Application No. 10/661,833  
Paper Dated April 15, 2005  
In Reply to USPTO Correspondence of December 15, 2004  
Attorney Docket No. 0388-031780

**REMARKS**

**AMENDMENTS TO THE DRAWINGS**

FIG.2

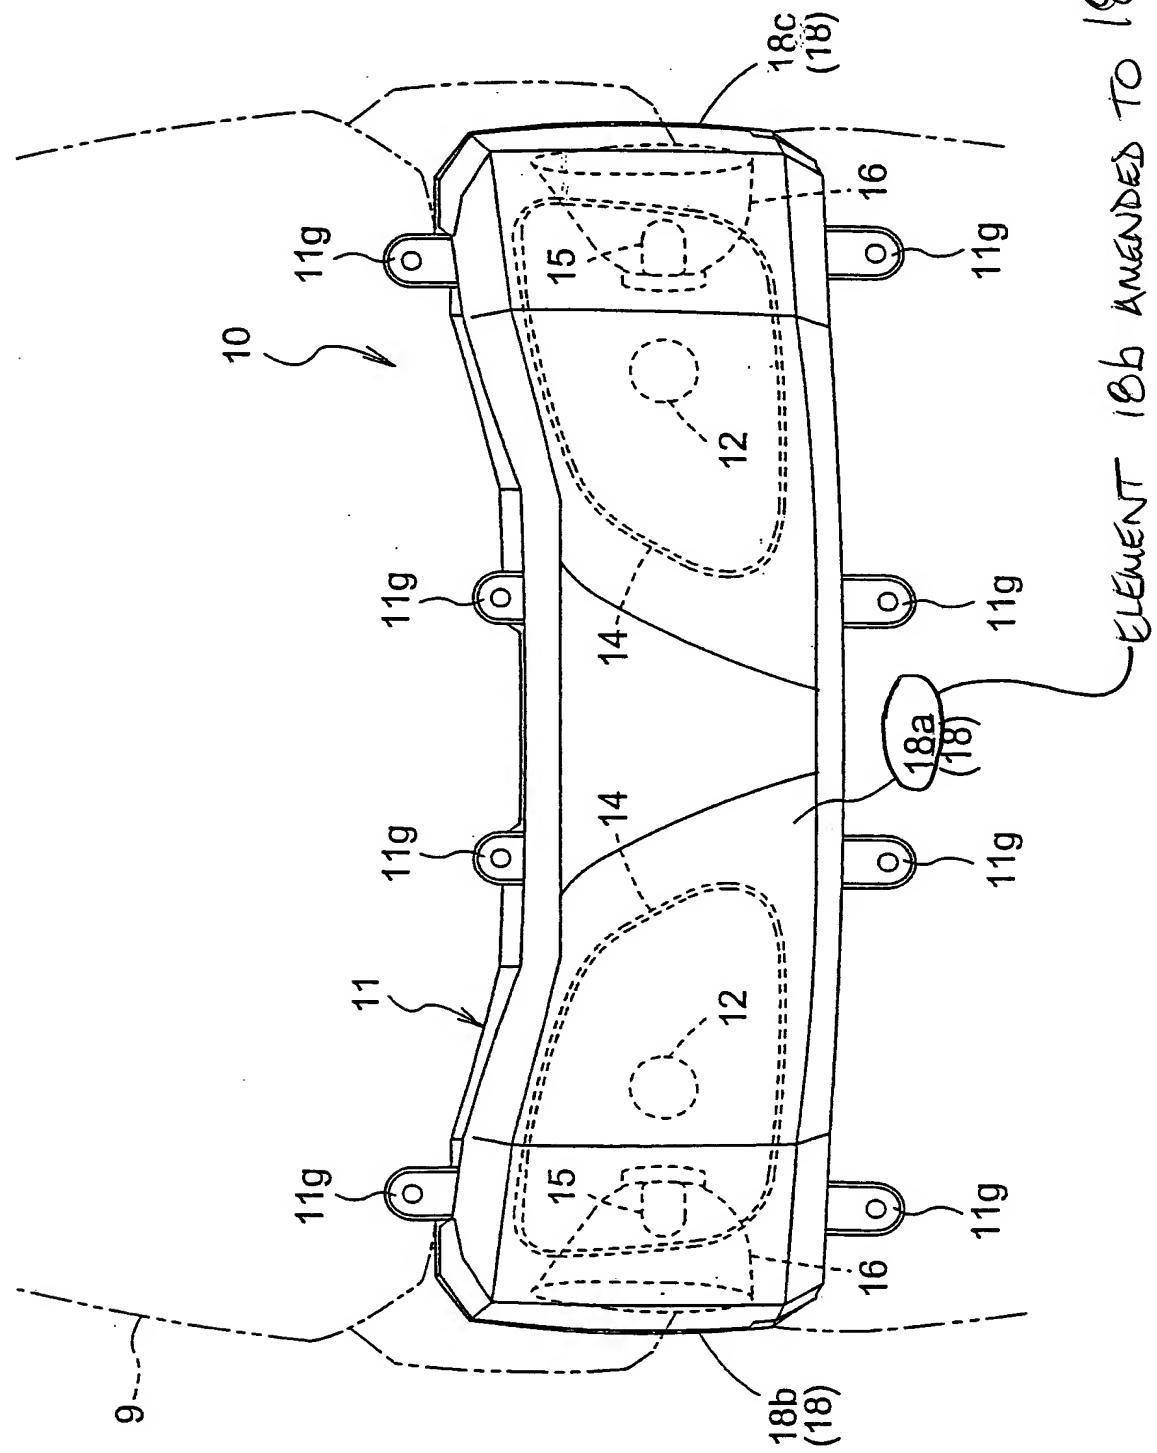
The attached sheets of drawings include changes to Fig. 2, Fig. 3 and Fig. 4. The attached sheets, which include Figs. 2-4, replace the original sheets including Figs. 2-4. In Fig. 2, an element 18b has been amended to element 18a. In Fig. 2, Fig. 3 and Fig. 4, an element 18b has been amended to element 18c.

FIG.3

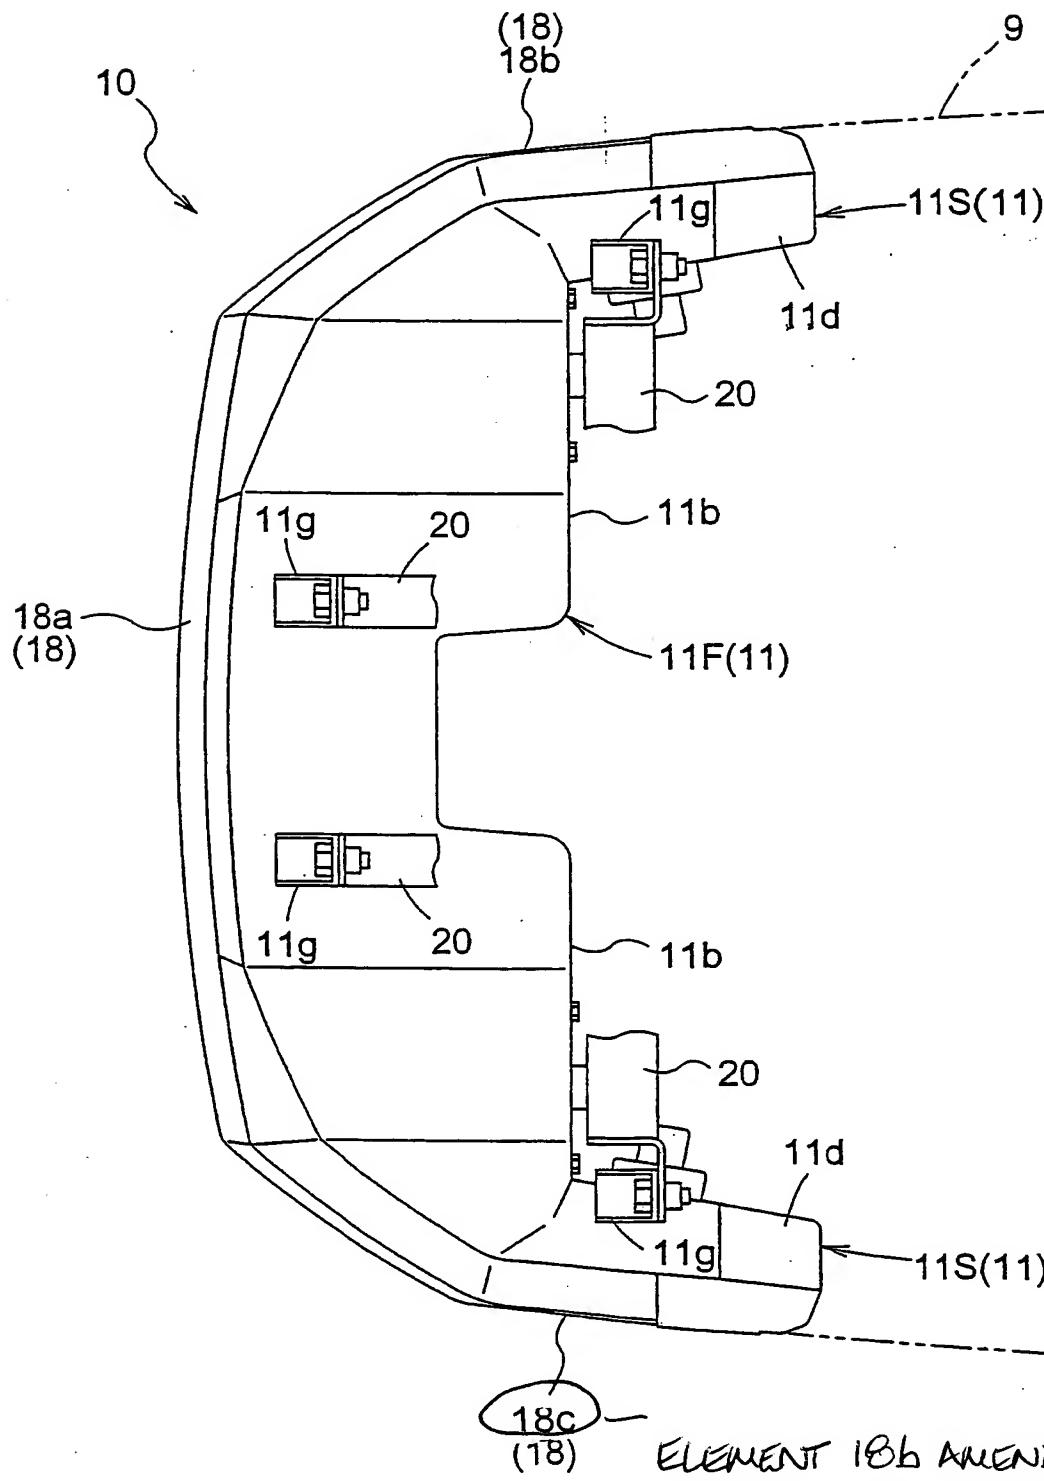
ELEMENT 18b AMENDED TO  
18c

FIG.4

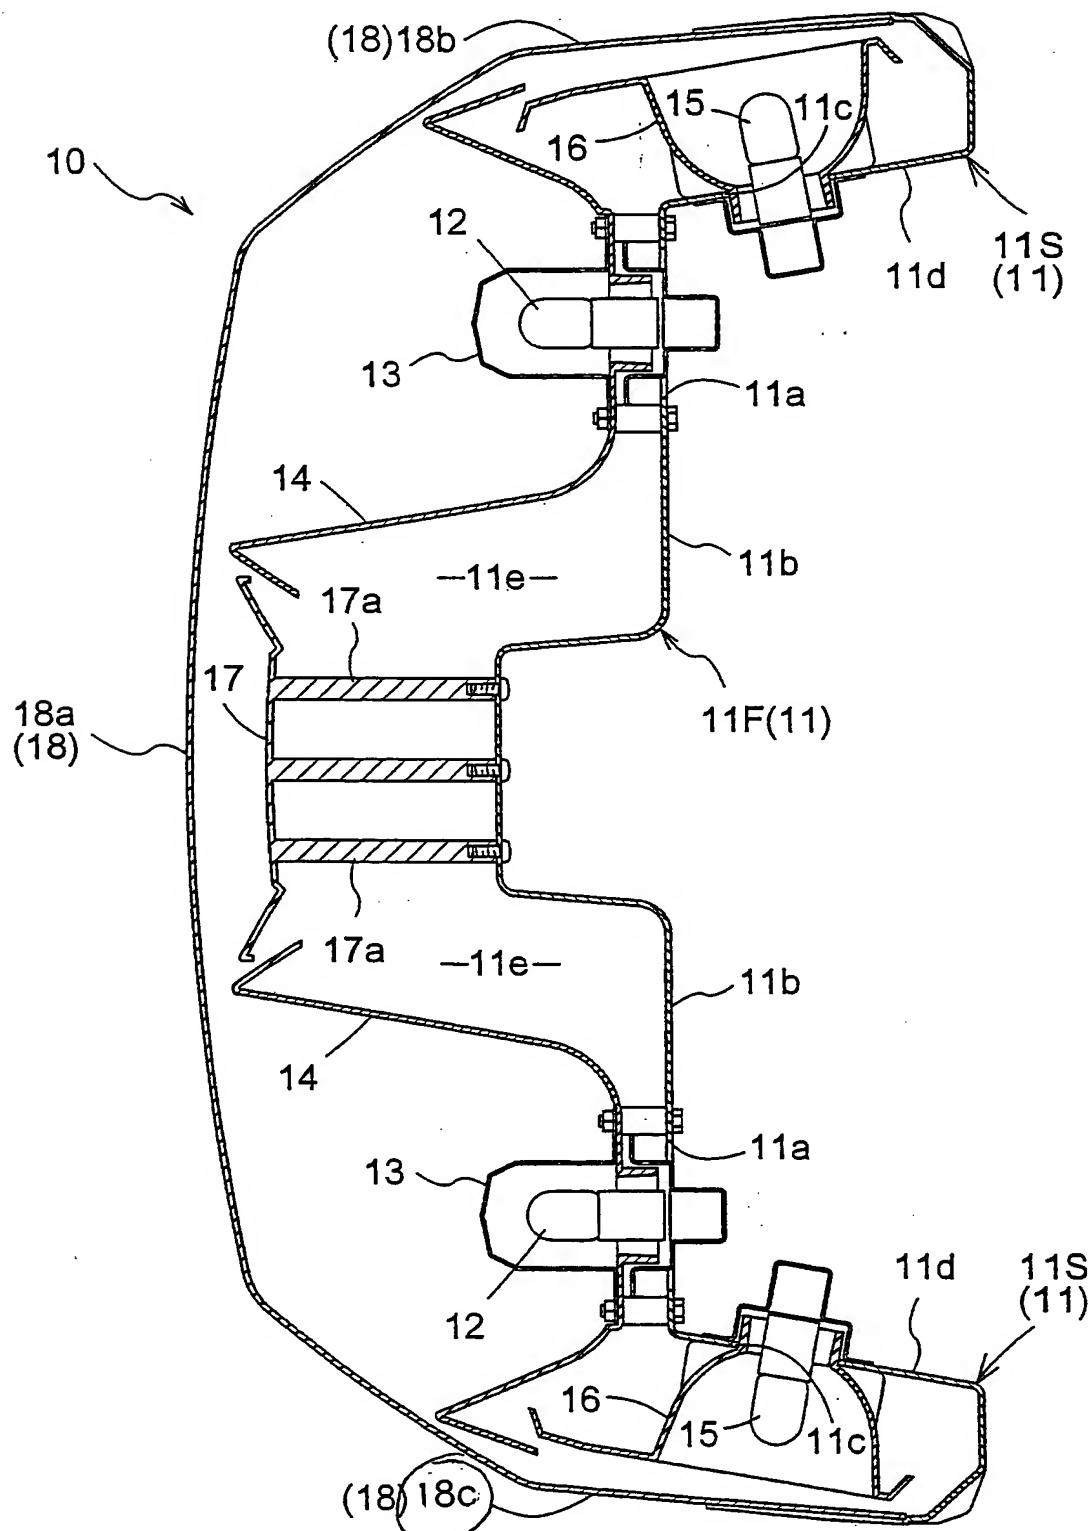
ELEMENT 18b AMENDED TO 18c
